Project No. 2628-066
R.L. Harris Hydroelectric Project
Response to Recommendations and Comments on Notice of Ready for Environmental Analysis

ALABAMA POWER'S RESPONSE TO RECOMMENDATION AND COMMENTS ON
FERC'S NOTICE OF READY FOR ENVIRONMENTAL ANALYSIS, AND SOLICITING
COMMENTS, RECOMMENDATIONS, PRELIMINARY TERMS AND CONDITIONS, AND
PRELIMINARY FISH PASSAGE PRESCRIPTIONS

Fish Friendly Turbine Application Ranges

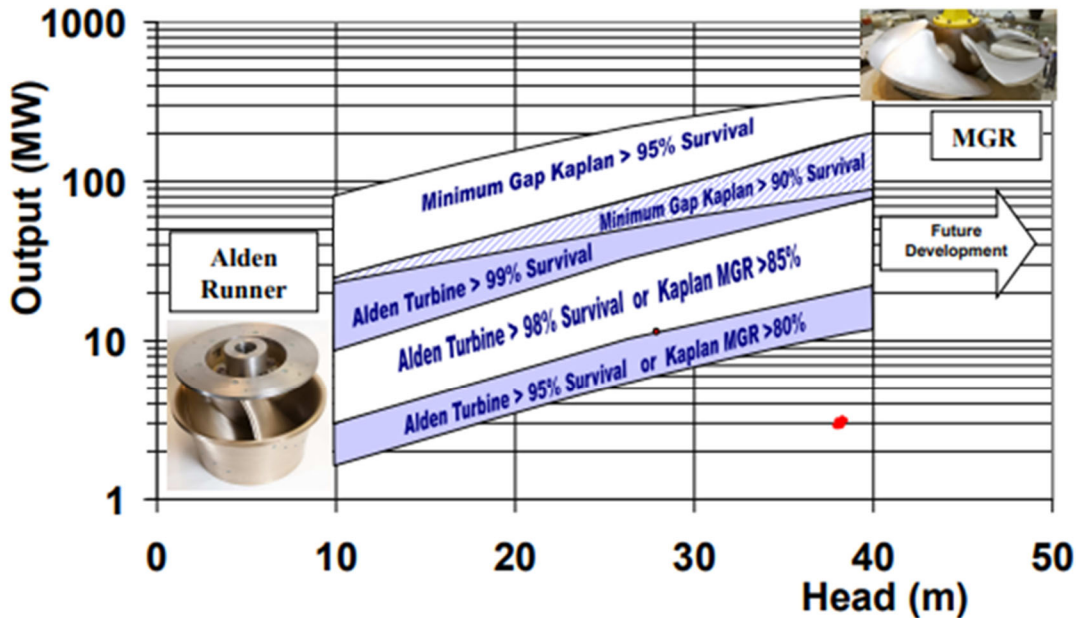
Comment: The estimations regarding fish entrainment and mortality included in the Desktop Entrainment, the Study Report, and the Pre-Application Document concluded that approximately 294,427 fish are lost annually due to the existing turbines, and an estimation of additional 12,691 fish could be lost due to the proposed new Francis-type turbine. Section 4.4 Turbine Characteristics and Fish Mortality only mention Francis and Kaplan turbine types. Fish friendly turbine types are not included or considered in the information.

The red dot on the figure represents the operating point of the proposed 300 cfs CMF at Harris Dam. For both of Voith's fish-friendly turbine types, the minimum flow unit falls well outside the application envelope. Additionally, there are limiting characteristics around the use of these designs, other than being outside the application range, that indicate why they are not a suitable choice for Harris. The proposed CMF design uses a compact package unit design with a horizontal orientation while the Voith designs are based on a vertical orientation. The current design was chosen to fit within the limited space of the area between the existing powerhouse and the spillway. The Voith Alden turbine diameter is typically about 50 to 55 percent larger than a Francis turbine for a similar application. This means not only would the unit need to rotate 90-degrees to a vertical orientation but also increase in diameter, which would require more space than is available.
